BABCOCK ROAD 165
PLANNED UNIT DEVELOPMENT (PUD) PLAN

A memo from the
CITY of SAN ANTONIO
Development Services
Master Development

SUBJECT: # 06-032

Name: Babcock Road 165 PUD

TYPICAL STREET SECTION - KYLE SEALE PKWY
N.T.S.

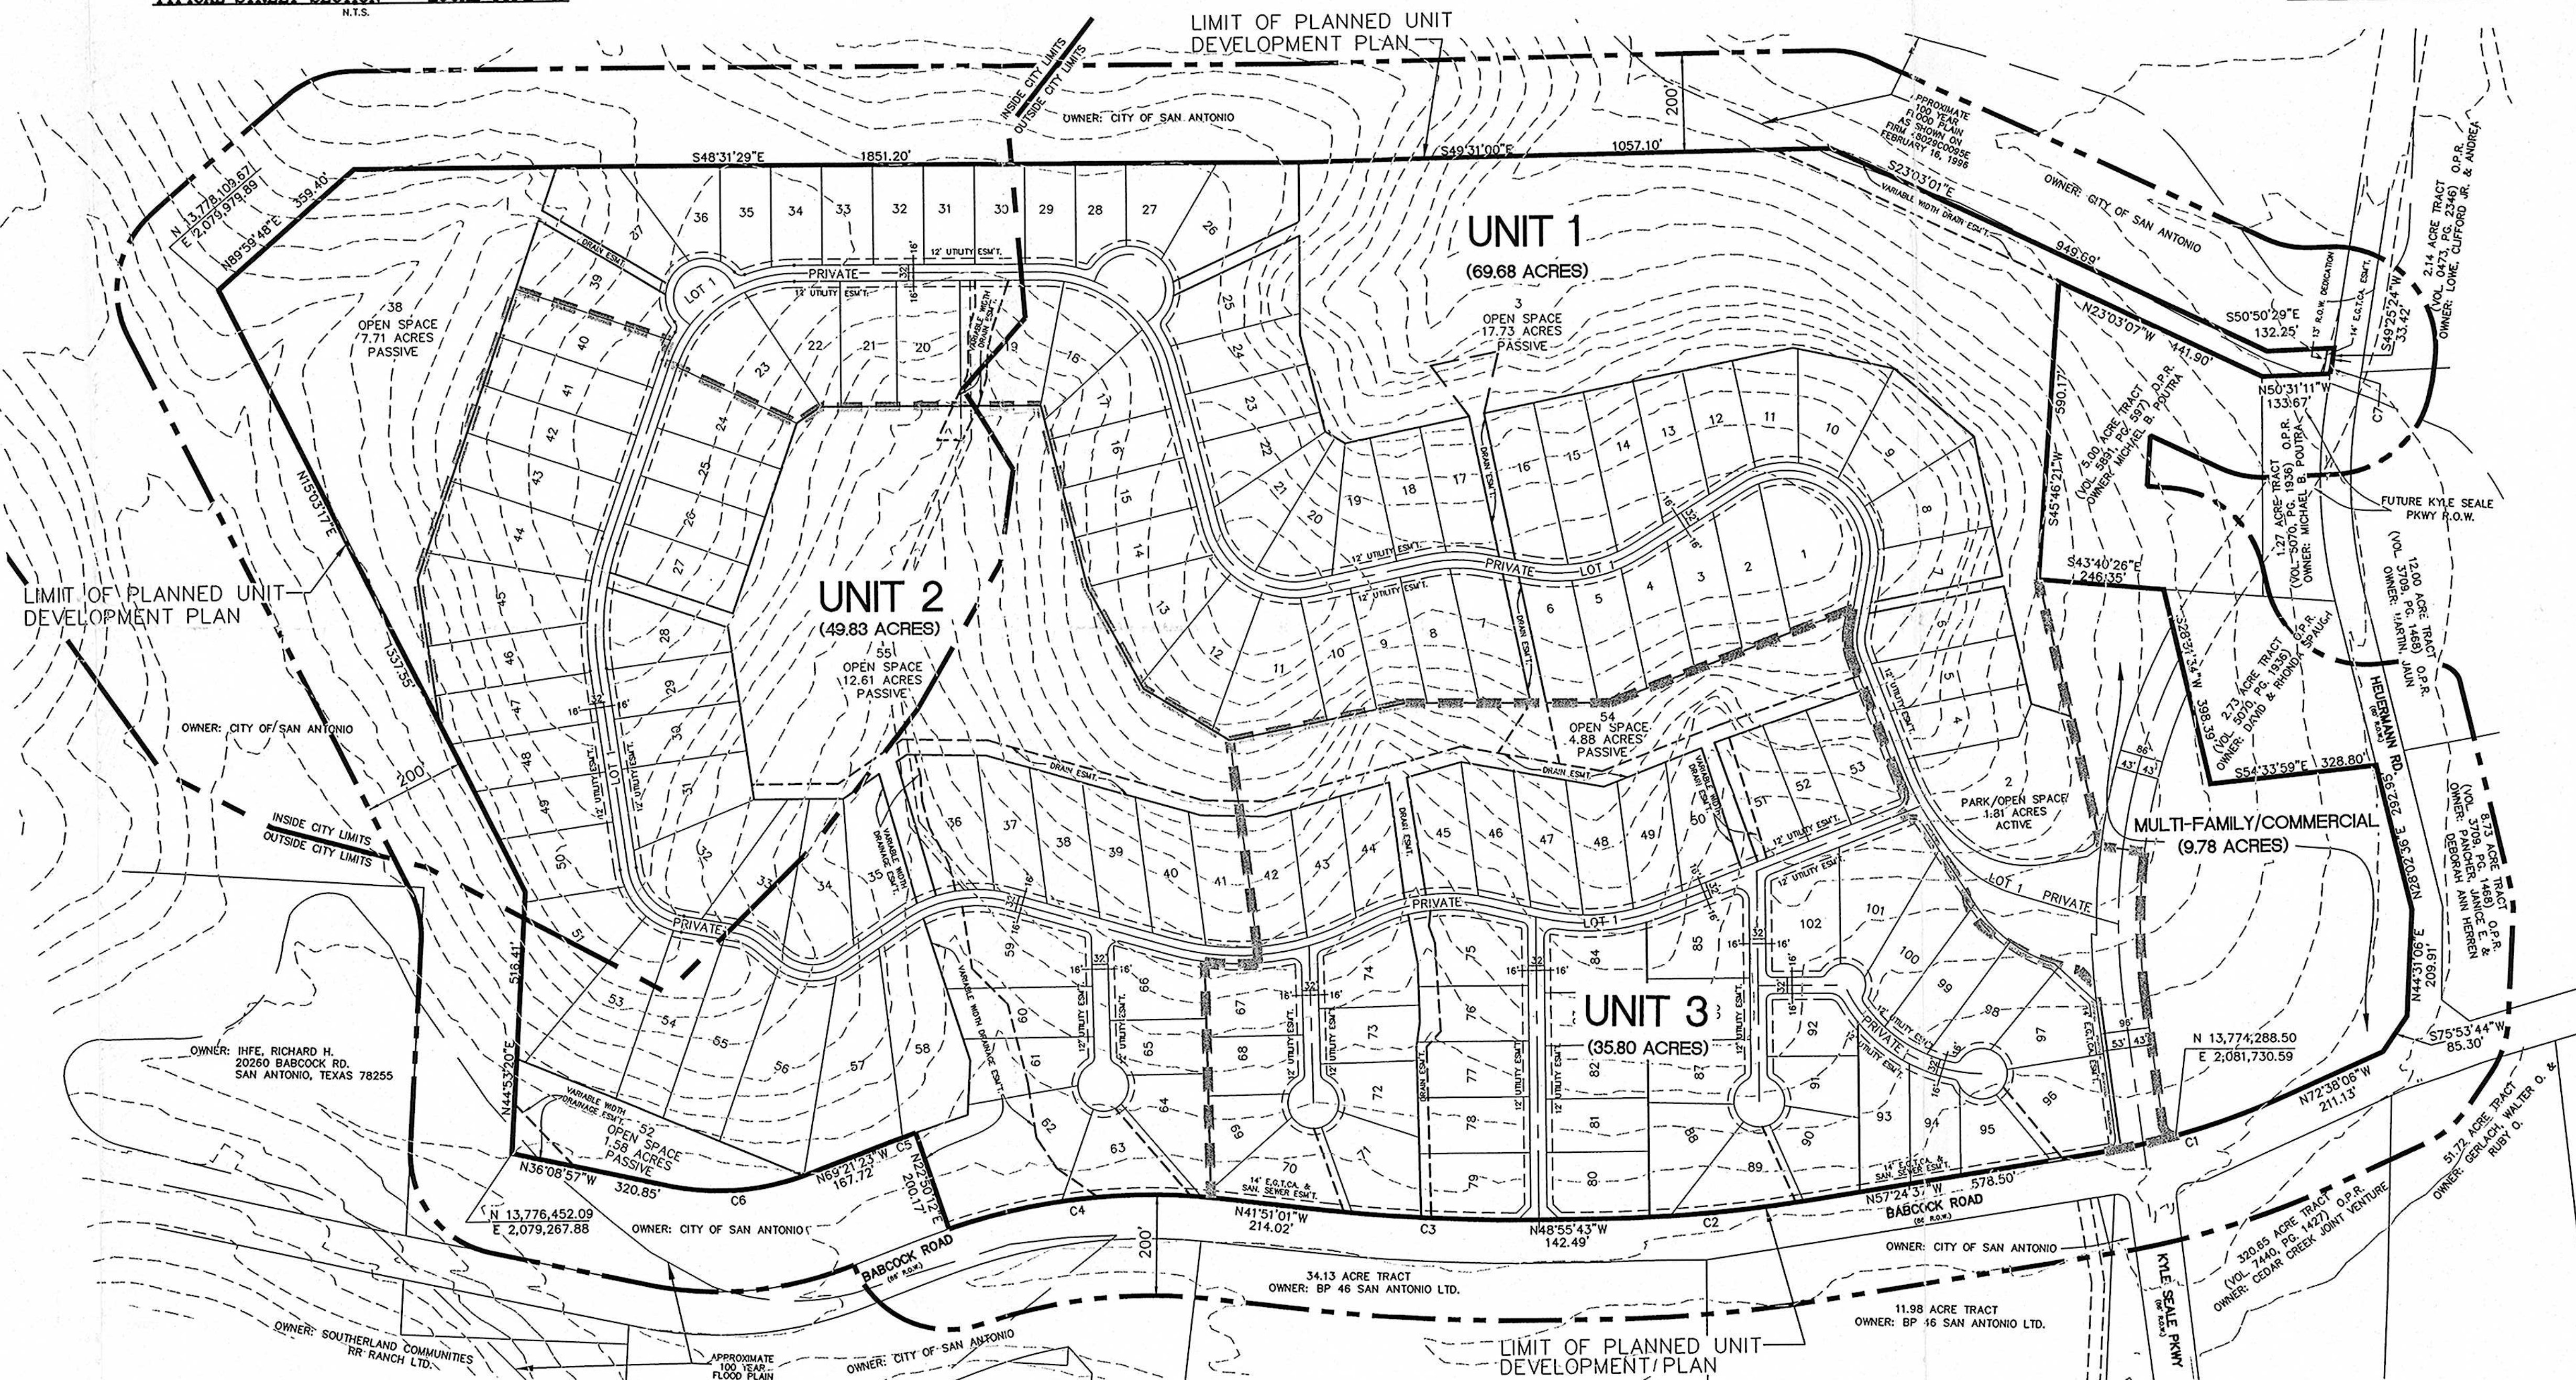
1. Dedicate and construct Kyle Seale Parkway as a secondary arterial type "A" four lane divided roadway, within the limits of this PUD.
2. Provide a minimum of 100-foot queue storage for the residential entrance from Kyle Seale.
3. A median opening on Kyle Seale Parkway will be allowed 480 feet east of Babcock for the residential access. However, if traffic demand for the westbound Kyle Seale Parkway creates queuing problems in the future due to the proximity of residential entrance to Babcock, the median opening may be closed.
4. The developer shall coordinate with Jim Brannan, P.E. (210-335-6711) at Bexar County for the extension of Kyle Seale Parkway due to a current Capital Improvement Project on Babcock Road .
